# EXHIBIT 23

## 3<sup>RD</sup> ROUND PLANT AND NON-TRANSMISSION COMPLETENESS RESPONSES FPL-TURKEY POINT UNITS 6 & 7 SITE CERTIFICATION APPLICATION

3<sup>RD</sup> ROUND PLANT AND NON-TRANSMISSION COMPLETENESS RESPONSES  
FPL-TURKEY POINT UNITS 6 & 7 SITE CERTIFICATION APPLICATION

Figure 3FDEP-VI(CAMA)-6-1  
Time History Plot – BNP Site 12 Bottom – Weekly Average Salinity, 2004-2009

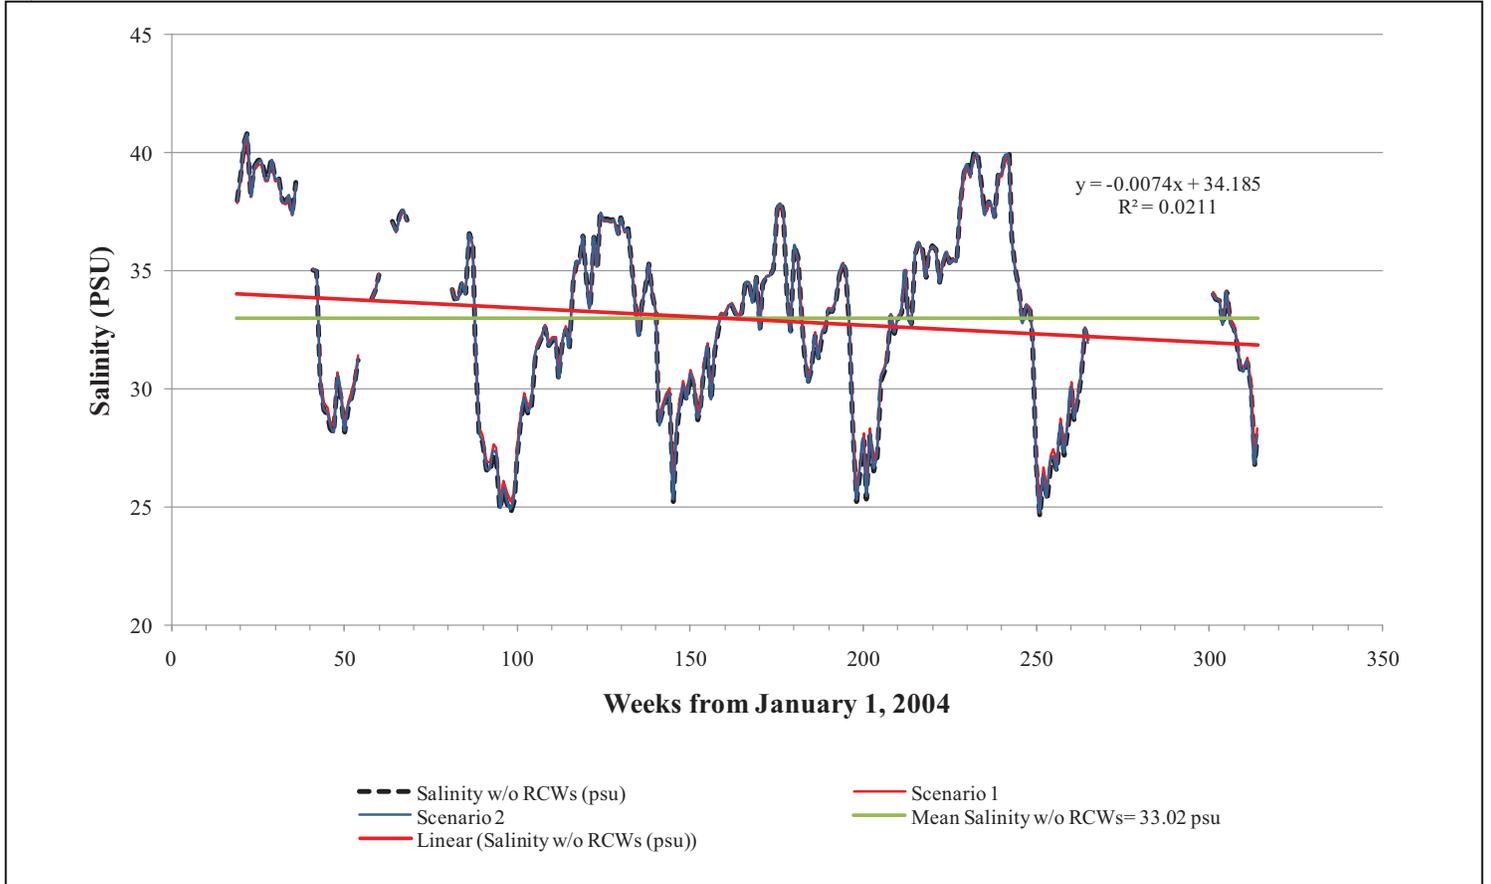
**3FDEP-VI (CAMA)-6: FPL’s response to this question states that “The ocean is the ultimate source of water flowing into the Bay to replace water withdrawn by the radial collector wells. Operation of the radial collector wells does not change precipitation, evaporation or freshwater inflow from upland areas. Therefore, the ocean salinity concentration of 35 ppt should reflect the ocean salinity. It should not represent the seasonally variable salinity within Biscayne Bay.” While there is a semi-diurnal tidal phase in Biscayne Bay that is influenced by the ocean, the water that resides in Biscayne Bay in any one basin at any one time is greatly affected by groundwater inflow from the bay bottom and tributary discharges, wind patterns and other variables. Salinities are typically lower along the shoreline, between a few hundred meters to 1000m and during the wet season (Langevin, 2001). The referenced county water quality site, BB41, is a surface water sample site approximately 4 miles west of Turkey Point peninsula and does not reflect a near-shore salinity regime, which fluctuates seasonally. It also does not reflect the salinity at or near the bay bottom, the depths most likely to be impacted by operation of the RCWs. Please provide more accurate data for salinity in the vicinity (such as data collected on a continual basis and particularly in the vicinity of the Turkey Point) and explain how this affects the results possible impacts by the RCWs. Continuous sampling results with a frequent timestep obtained from the bay bottom are most appropriate in developing a realistic salinity impact analysis, and a bay bottom depth profile represents the depth of most probable impact by the RCWs.**

The initial comment above regarding ocean salinity is correct. In the salinity impact analysis, the value represents ocean salinity; it does not represent a seasonally variable salinity within the Bay. While station BB41 is about 3.5 miles northeast of the Turkey Point peninsula, studies conducted by FPL (discussed in 1<sup>st</sup> Round Plant and non-Transmission Response SFWMD-B-60, October 2009) and by Stalker (2008) show that the average salinity in this area is similar to the salinity found at other stations around the Turkey Point peninsula. Furthermore, studies by Stalker (2008) show that this area of the Bay has a freshwater fingerprint (i.e., percent composition of canal water, groundwater and precipitation) that is similar to the composition of the fresh water predicted by Stalker for the area around the Turkey Point peninsula (see Figures 2.13 and 2.14, Stalker, 2008). Therefore, the salinities at this station are representative of salinities at the radial collector well site. In addition, FPL has provided the salinity impact analysis using data from station BISC122, which is located about 2 miles south of the Turkey Point peninsula. The conclusions remained unchanged. The radial collector wells will have no adverse impact on the salinity in Biscayne Bay.
